Central Falls High School

100% Construction Documents

Ai3 Project #2202.02

Addendum #7

4 WALL FOOTING

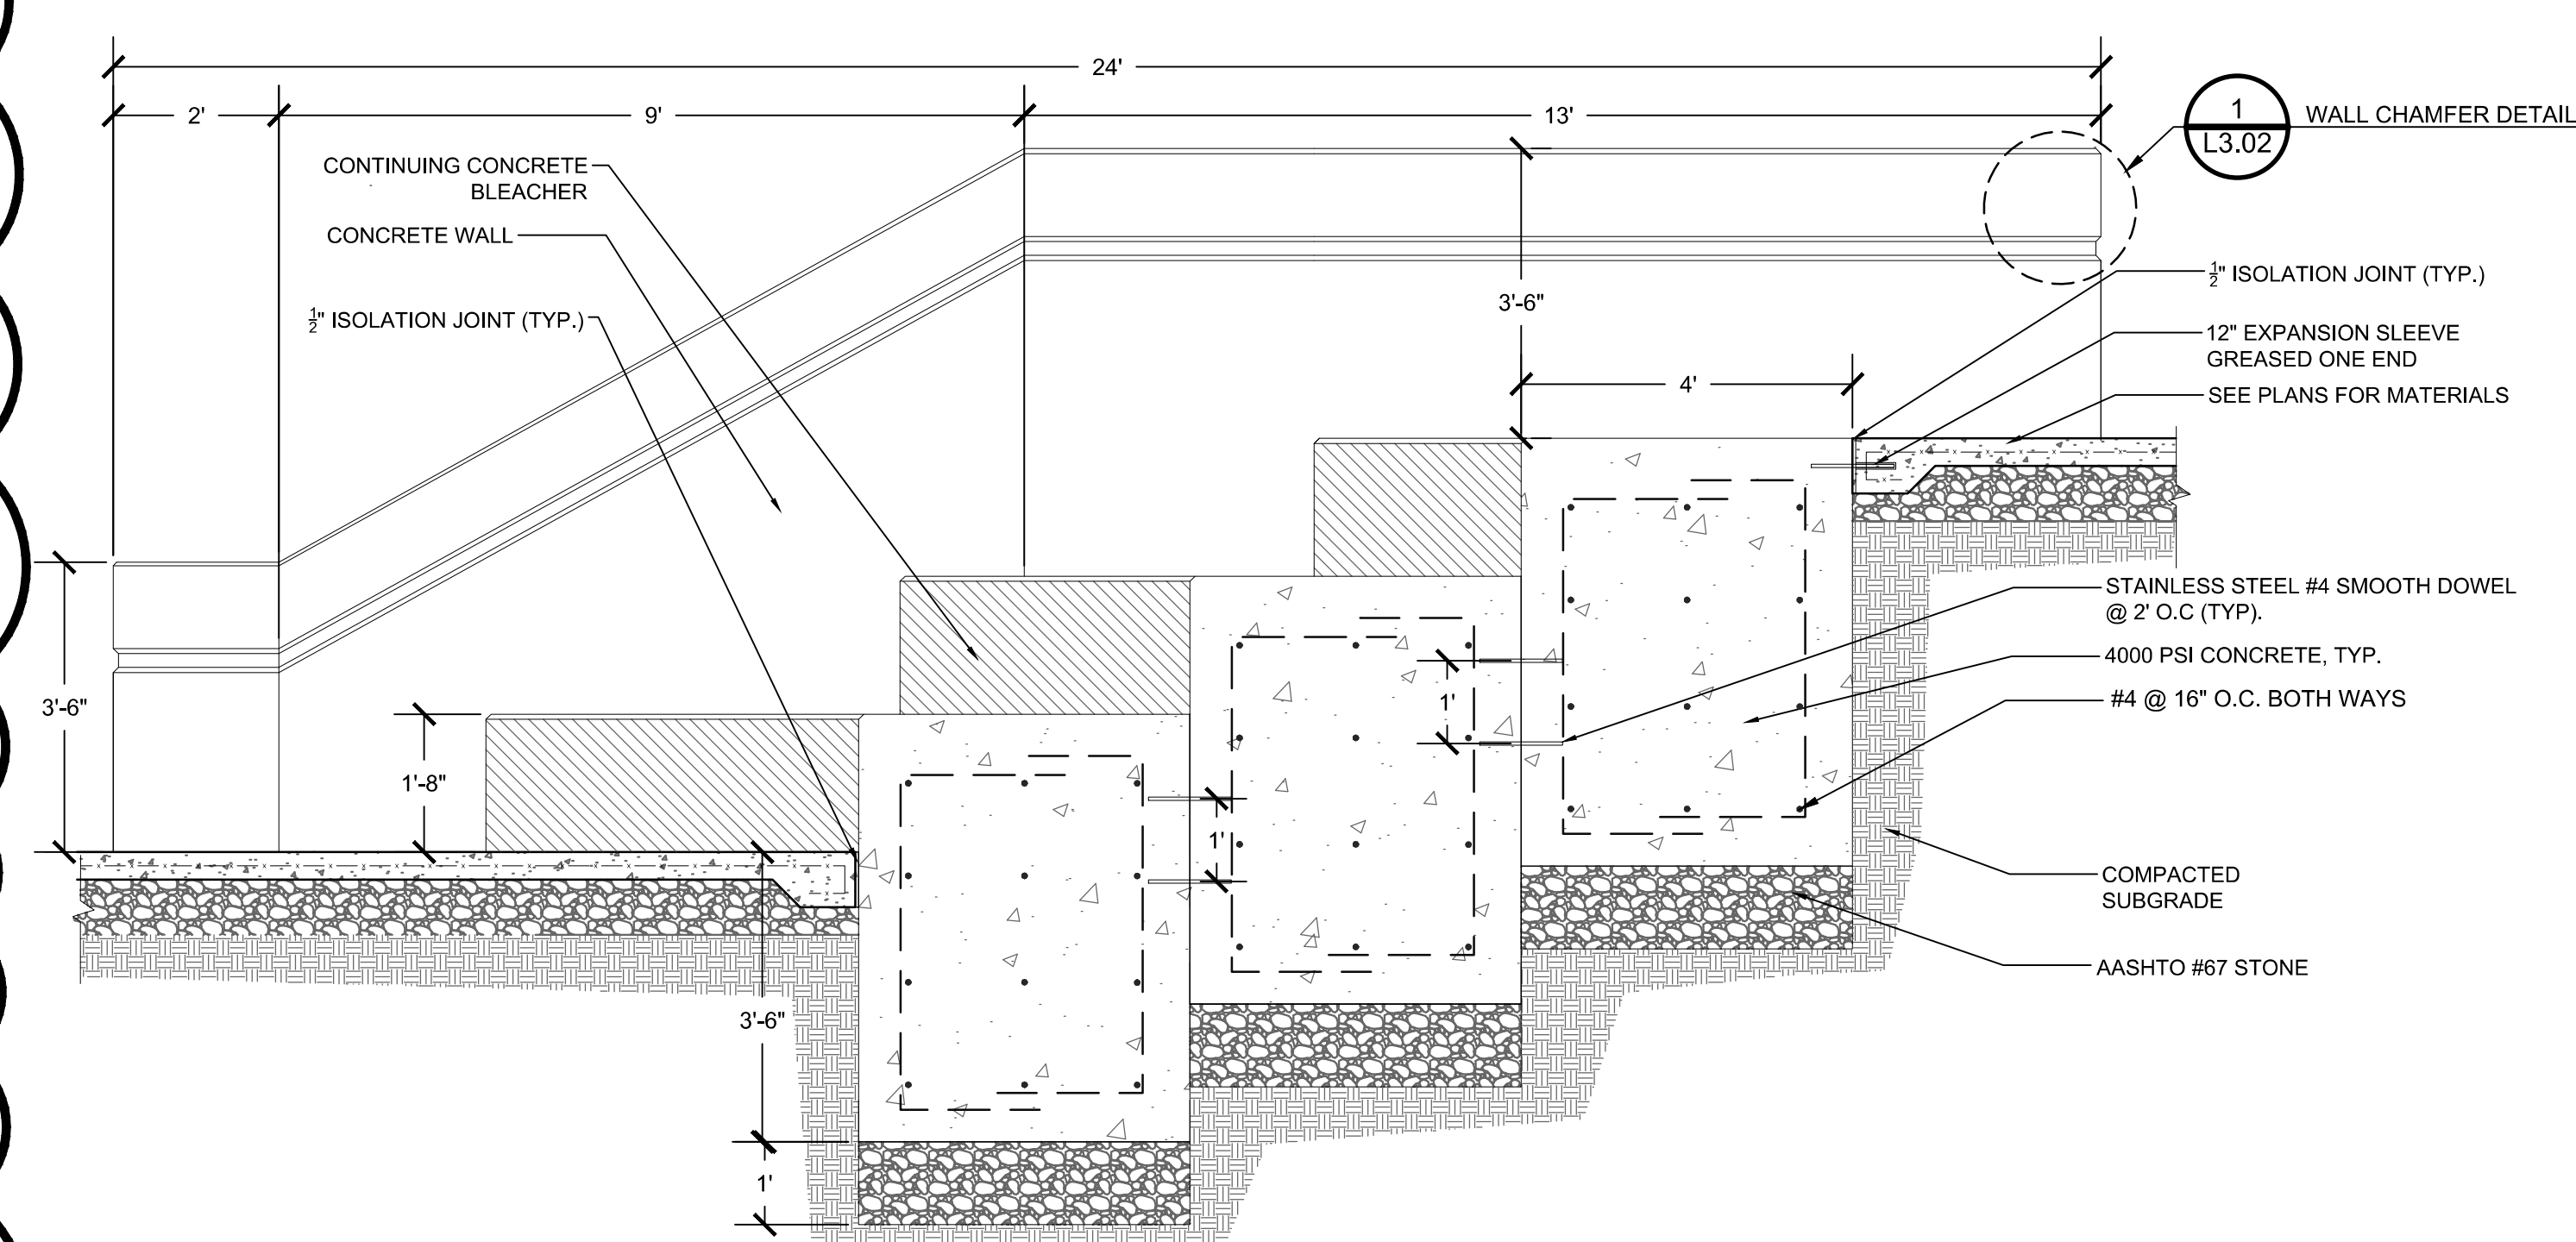
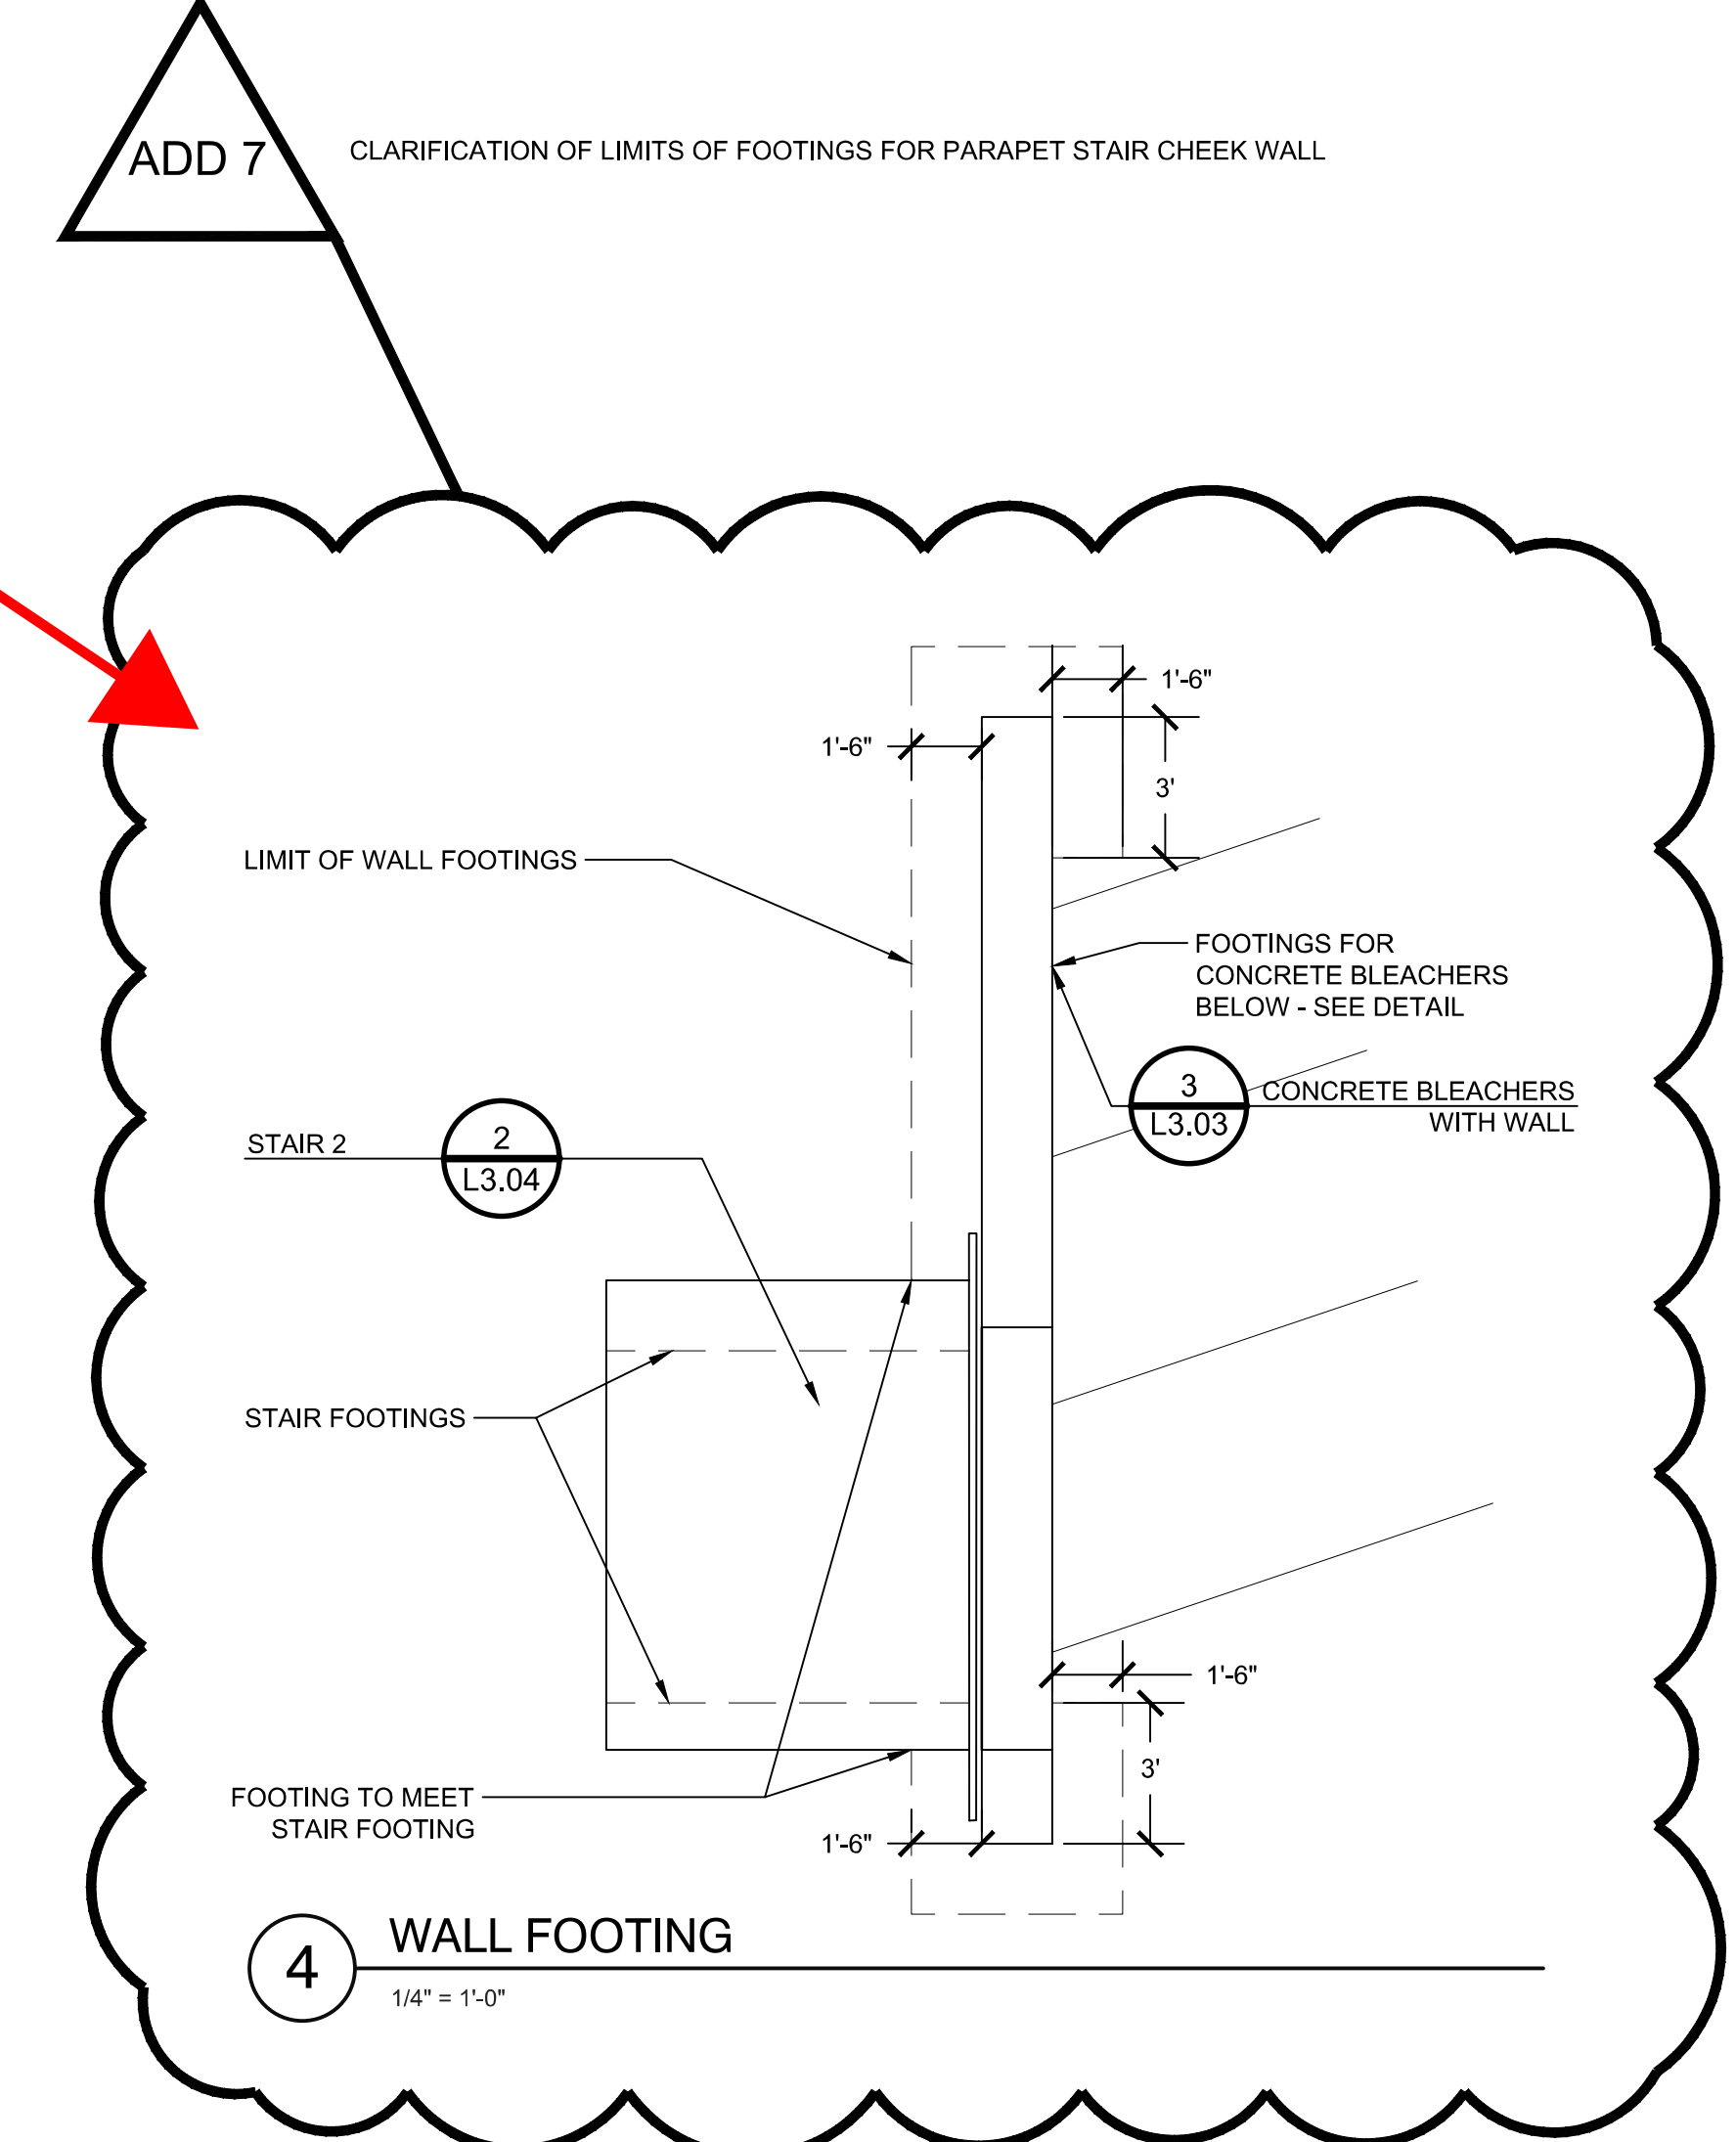
ADD 7 FOOTING DEPTH CHANGED FROM 3' TO 3'-6" ISOLATION JOINT CALLED OUT ON BLEACHER SIDE OF WALL DIMENSIONAL CORRECTION FOR HEIGHT OF WALL
